Sunnica Energy Farm Consultation on proposed changes

6 June to 6 July 2022

Introduction

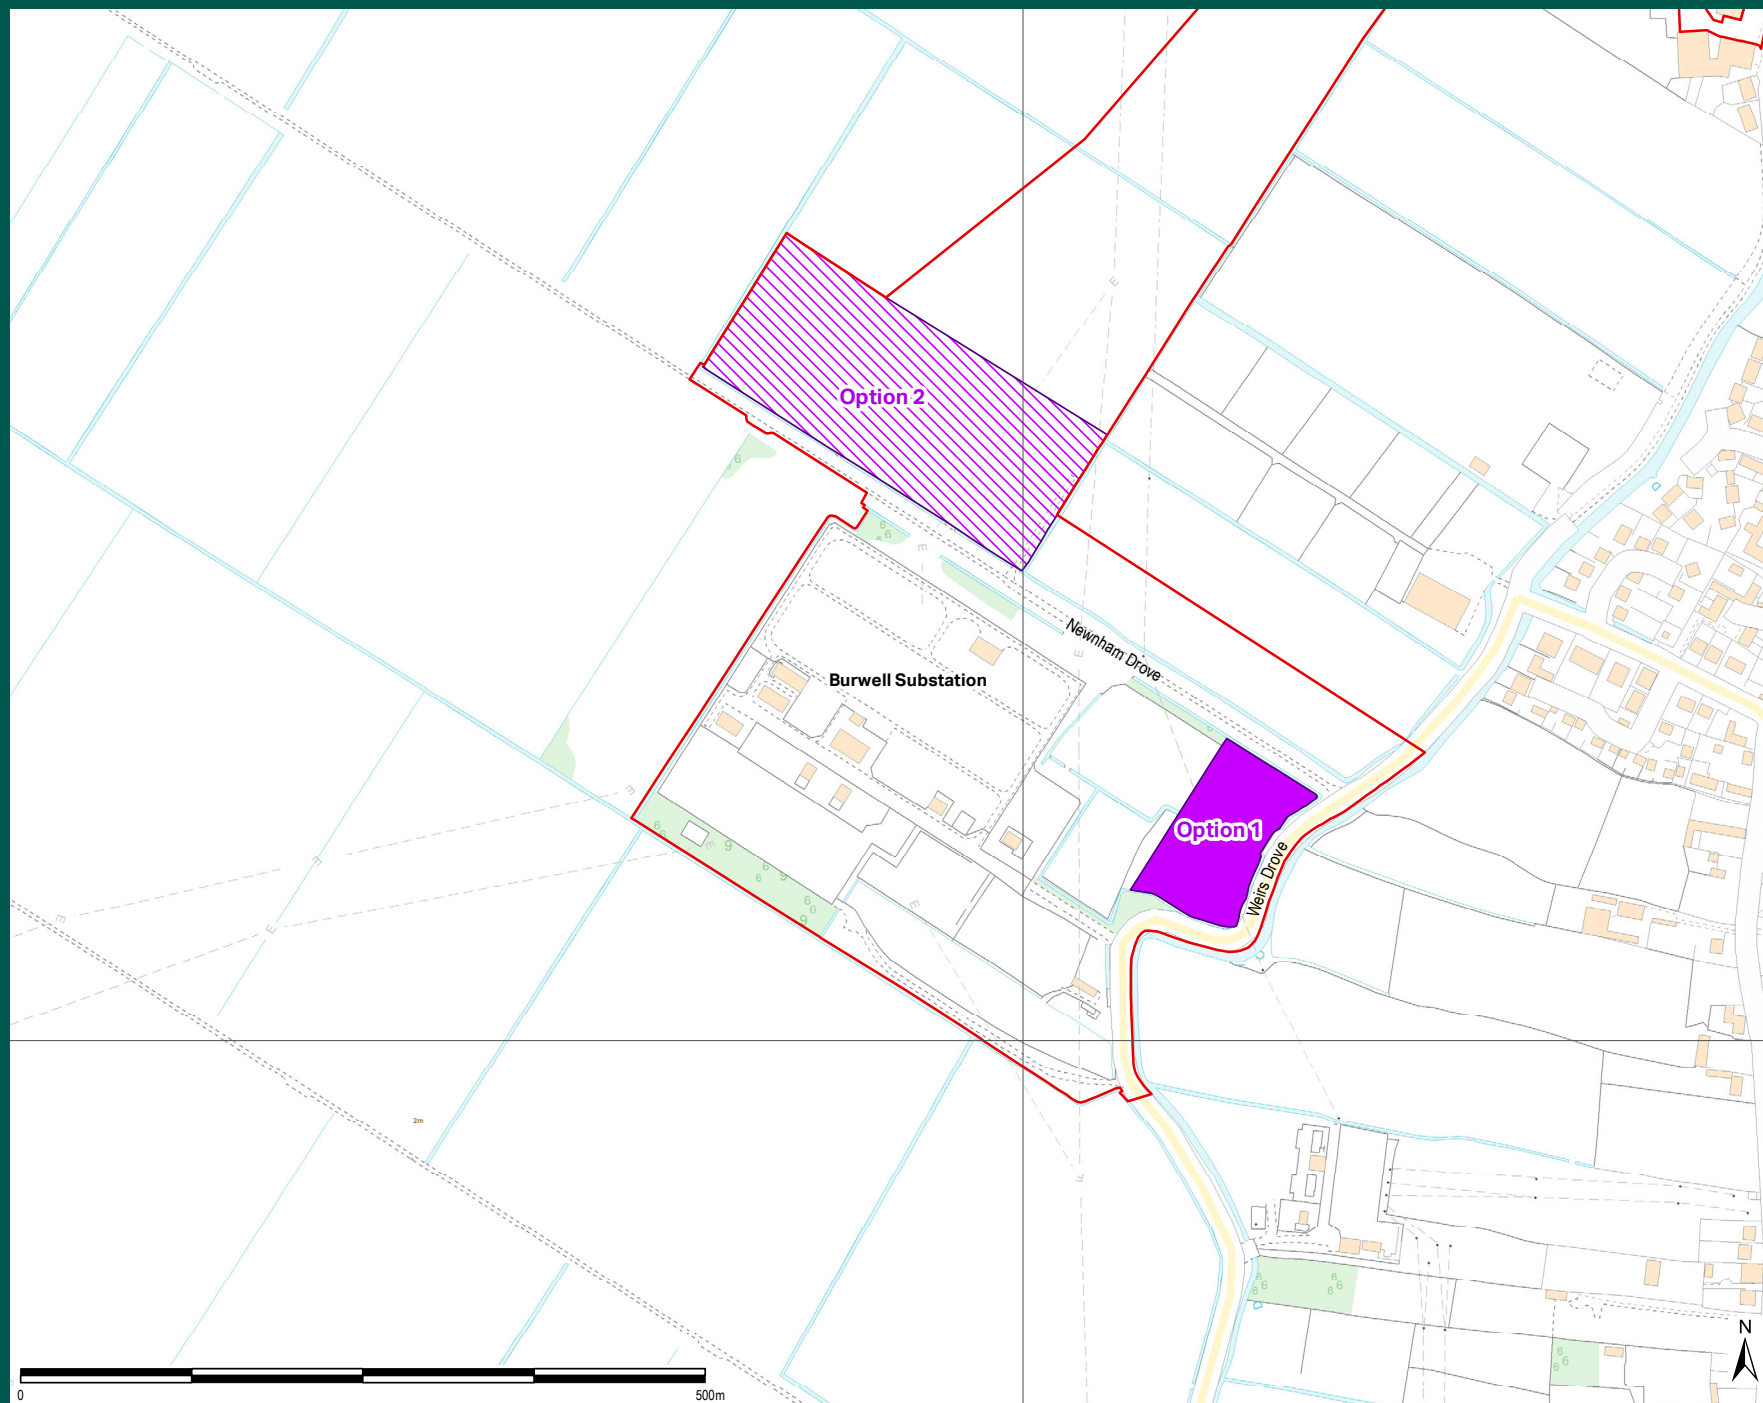
NGET has subsequently stated that our Option 1 substation extension is: “not

technically feasible given the amount of land now required by the Promoter, the planned extension of the substation and [National Grid Electricity Transmission] NGET’s license obligations”. As such, the representation suggested that we should take forward Option 2.

This review has led us to explore a different option - Option 3. This option would require amended substation and transformer arrangements at Sunnica West Site A, Sunnica East Site A and Sunnica East Site B alongside a shunt reactor at Sunnica East Site B. This revised arrangement would convert the power from the Scheme to 400kV and allow for a connection to be made to the Burwell National Grid Substation using a 400kV underground cable. This option would not require any extension at the Burwell National Grid Substation.

Change 1: To remove the Burwell National Grid Substation Extension Option 1 (this is the option located immediately to the east of the existing Burwell National Grid Substation and the land borders Weirs Drove and Newham Drove) from the Scheme.

The Burwell Substation extension Option 1 is proposed to be removed from the Scheme, although rights through this land may still be required for underground cabling. The need for the transformer compound at this location would be removed by changing the electrical configuration of the Scheme (as set out in Change 2 and Change 3) or by proceeding with Option 2 for the substation extension.
